PARKER P2105 PARTS IMPORTANT CORRECTIONS TO PARKER'S 2009 PDF

Identification, Correction and Acceptance Criteria

Document no: TA-LIF-001, Rev 1
Product: Parker P2105
Author: Andres Sabino
Date: 09/14/2026
Department: Engineering

P2105 - New Design Series 15

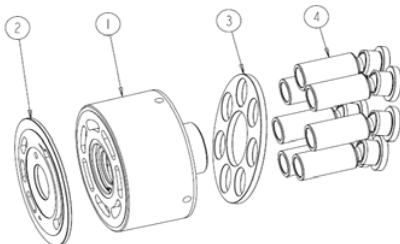
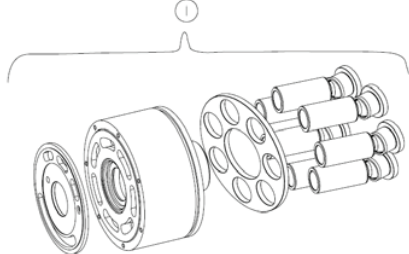
A) These part numbers are wrong on page 2. Below are the correct ones.

B) The Problem:

When they say "New S1 shaft version" on page 2, it is contradictory since this is a memo for a P2105 and the only S1 shaft available is for P2060.

P2-105-2412 kit valve plate CW

P2-105-2413 kit valve plate CCW
